ADDENDUM NO. 2 TO 12-0040-4

FOR: PIPEMAKERS CANAL WIDENING PHASE II SECTION 2 DRAINAGE IMPROVEMENTS

Pipemakers Canal
Phase 2 Section 2 Drainage Improvements
Addendum #2
June 26, 2012

FORCE MAIN RELOCATION PLAN PIPEMAKERS CANAL PHASE 2 SECTION 2 WIDENING

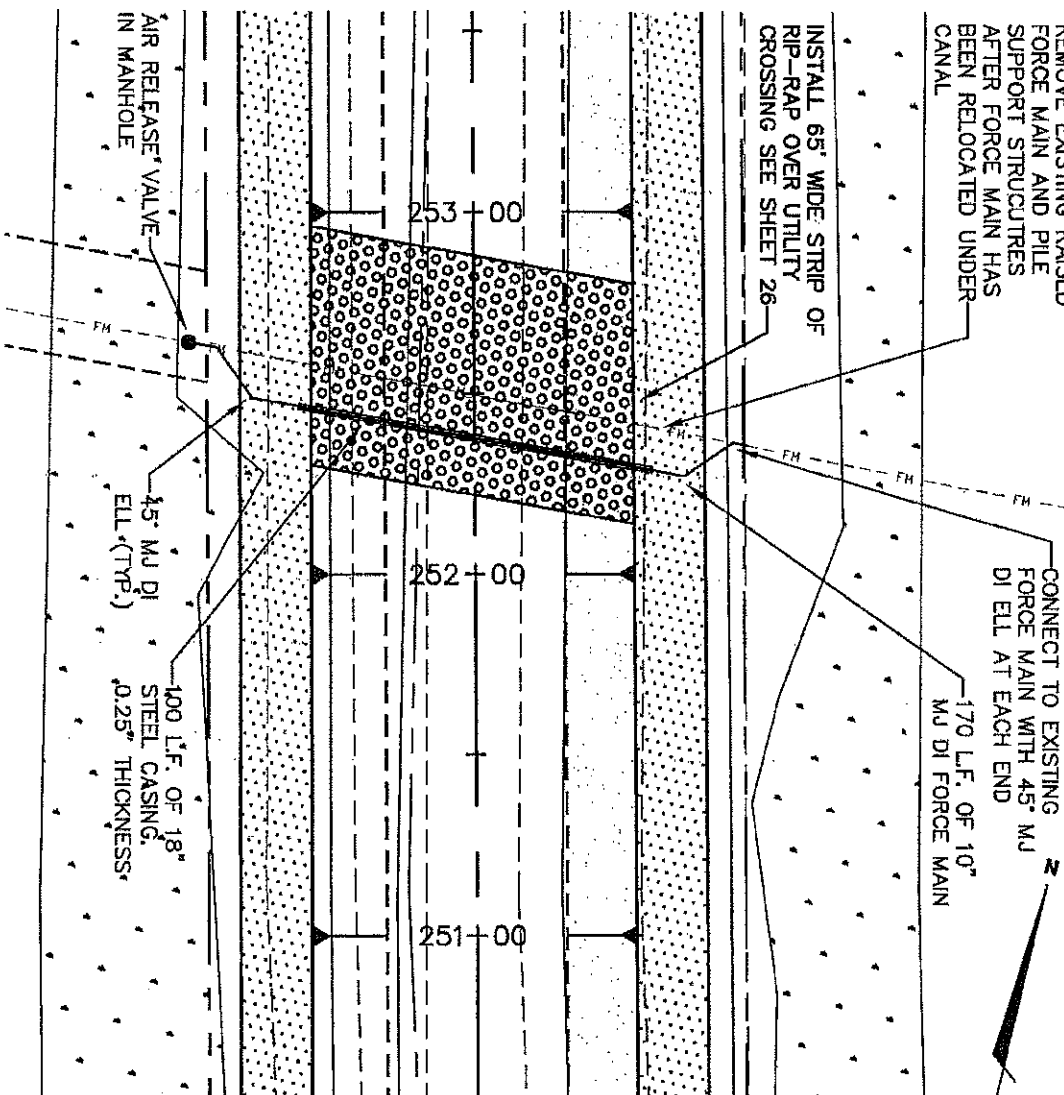
5. Question: Plans depict the force main relocation as a directional bore. The detail for construction uses ductile iron pipe through a casing. Which is correct?

6. Question: Plan sheet 17 has a depiction of the force main relocation that seems to indicate the requirement for taping sleeves and valves on each end, air release valves on each end and possibly line stops on each end. Please clarify what each of these symbols are on this drawing as the description of work calls for sleeve tie ins with a line shut down.

Answer: Sheet 17 of the drawings shows a 10" force main and 16" water line to be installed by others. Sheet 17 has 2 notes that pertain to the installation of these utility lines. These two utility lines will not be installed as outlined by the drawings and notes on sheet 17. Drawings are attached that show how the force main will be relocated. The force main connections shall be performed by taking it out of service. The procedure for making the force main connections by taking it out of service is generally described as follows:

- A. Install all force main, casing, valves, and fittings up to the tie in points on each end of the force main.
- B. Pressure test new force main.
- C. Have all necessary materials and equipment at the job site to make both connections at each end of the force main simultaneously.

- D. Take the existing force main out of service. The force main can be taken out of service for up to 5 hours on a Saturday or Sunday during the daytime. A three day written advance notice will be required by the contractor prior to taking the force main out of service. The operator of the lift station will notify the users of the sewer system one day in advance when the lift station will be taken out of service in order to draw the station down to allow for maximum storage in the wet well. At minimum of three vac-trucks of the largest size available will be required to be present at the lift station to remove sewage as needed. One contractor employee will be present to monitor the lift station site while it is out of service.

- E. Once the force main is out of service work shall be performed continuously to make the connections at each end of the force main simultaneously.
- F. Prior to performing the forcemain connections the contractor shall submit a plan to the owner for review. The plan shall include the following at a minimum.

Shop drawings will be required for all materials used for the force main relocation. The contractor's price to relocate the force main includes all necessary labor, materials, and supervision to relocate the force main as shown. The cost for the three vac-trucks and disposal of sewage during the 5 hour shut down period is included in the contractor's relocation price. Any cost associated with the vac-trucks after the 5 hour shut down period shall be at the cost of the contractor.

FORM 7460-1 PROJECT WORKING LIMITS EXHIBIT PIPEMAKERS CANAL PHASE 2 SECTION 2 WIDENING PROJECT

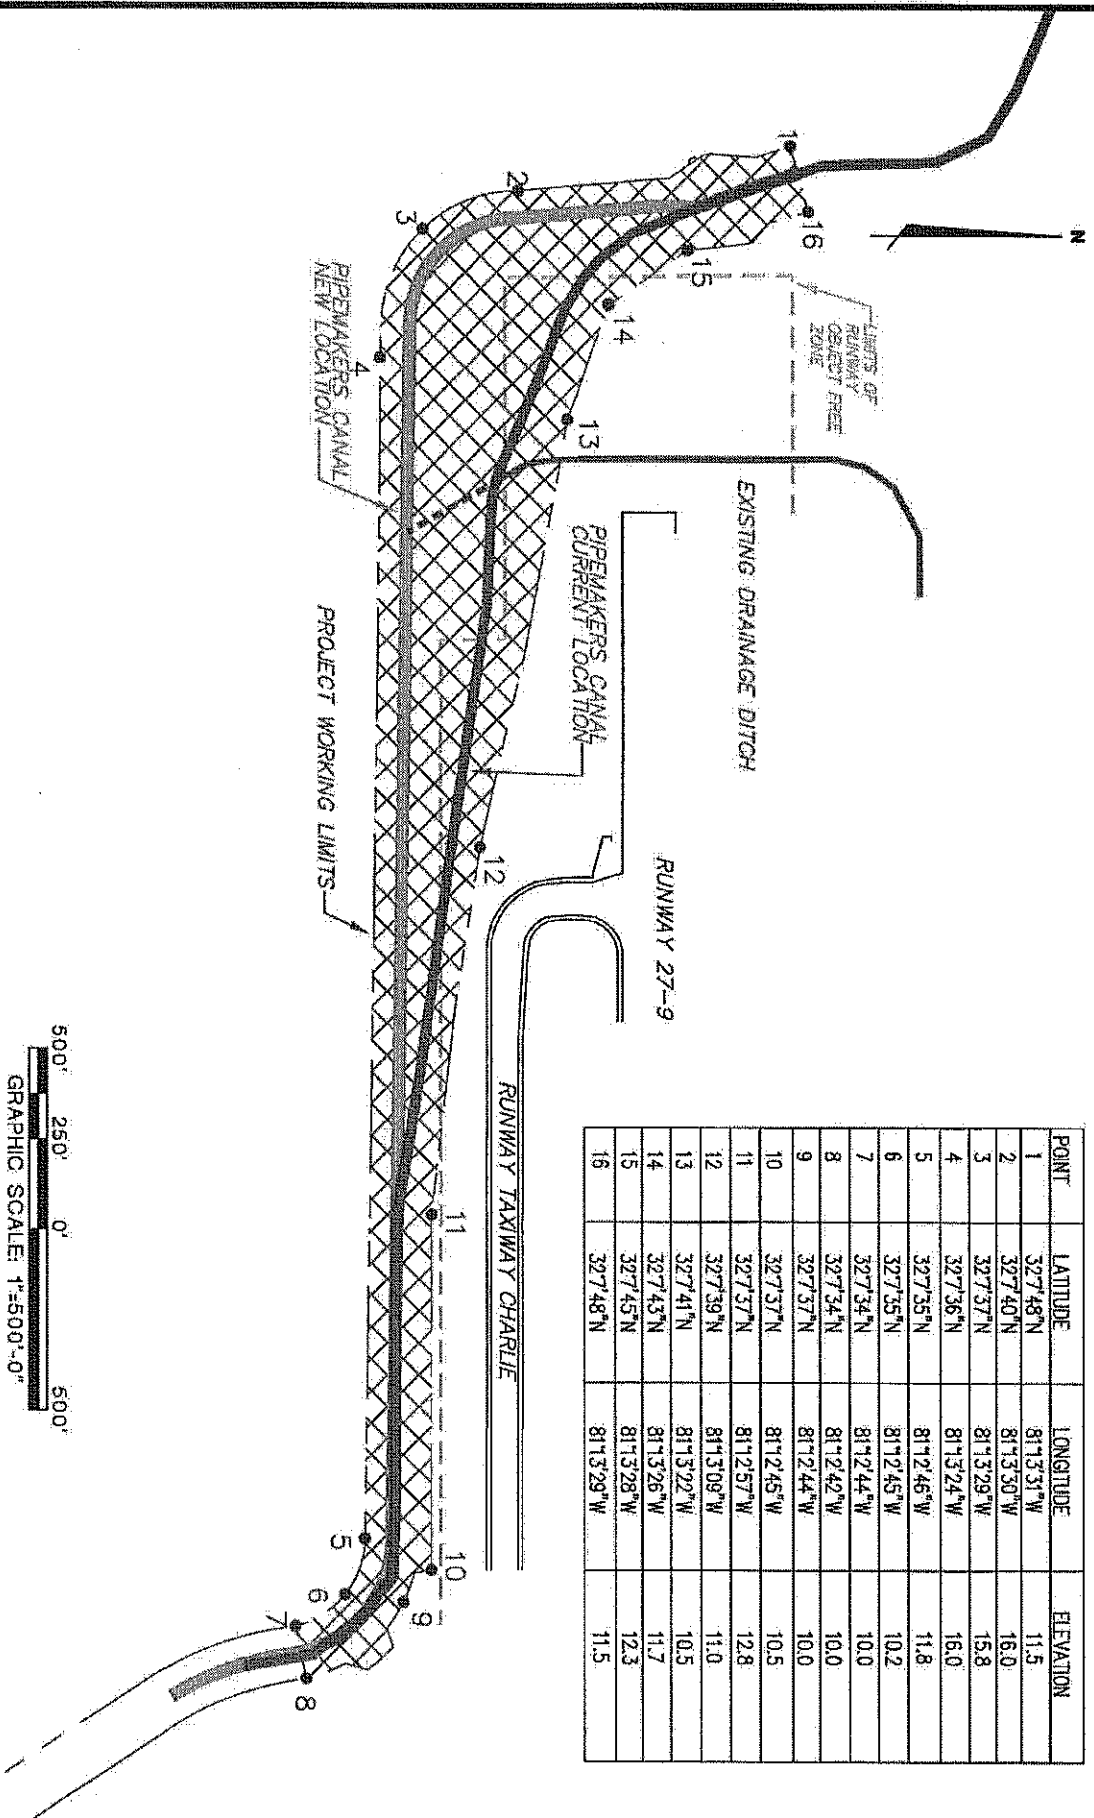
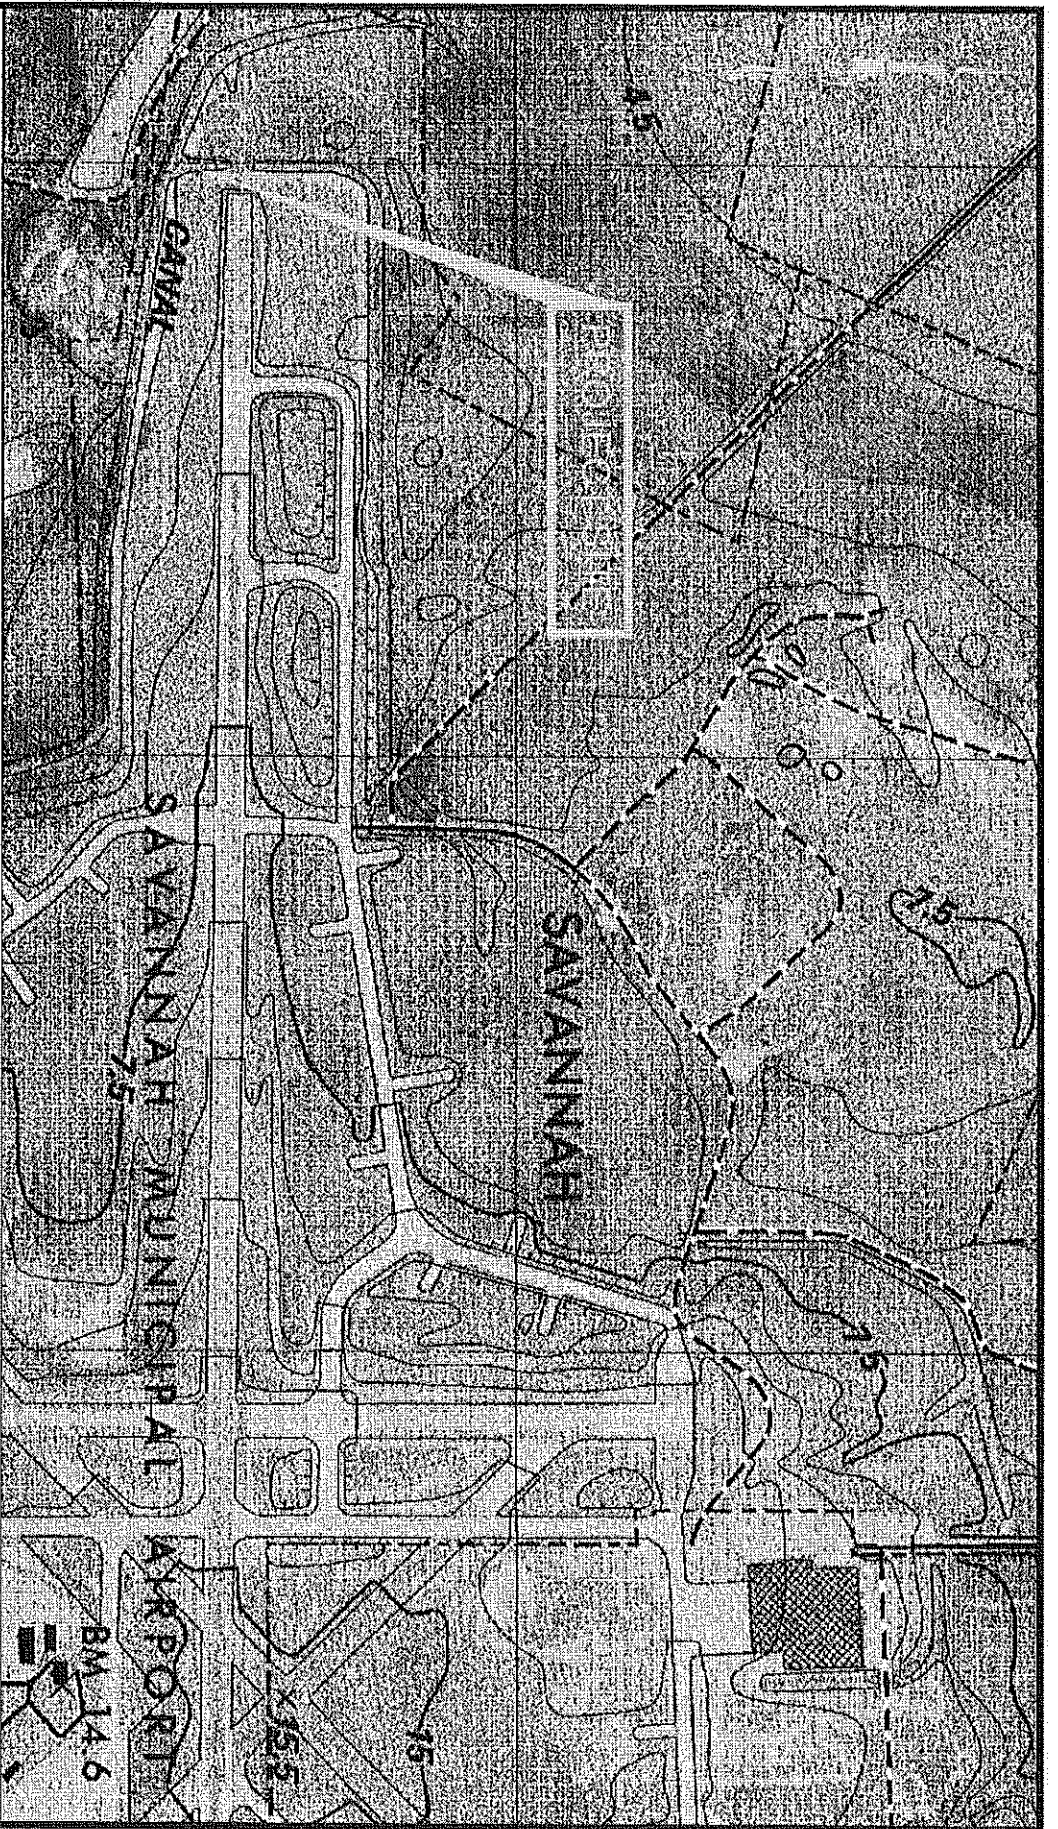
ILS requirements will be determined when the FAA performs the 7460-1 study. There may or may not be effects on the ILS system depending on the results of the 7460-1 study. The contractor that is awarded the contract shall have to abide by the results of the study. The critical area for the ILS represented on the runway protection zone exhibit. Other areas may be specified by the FAA.
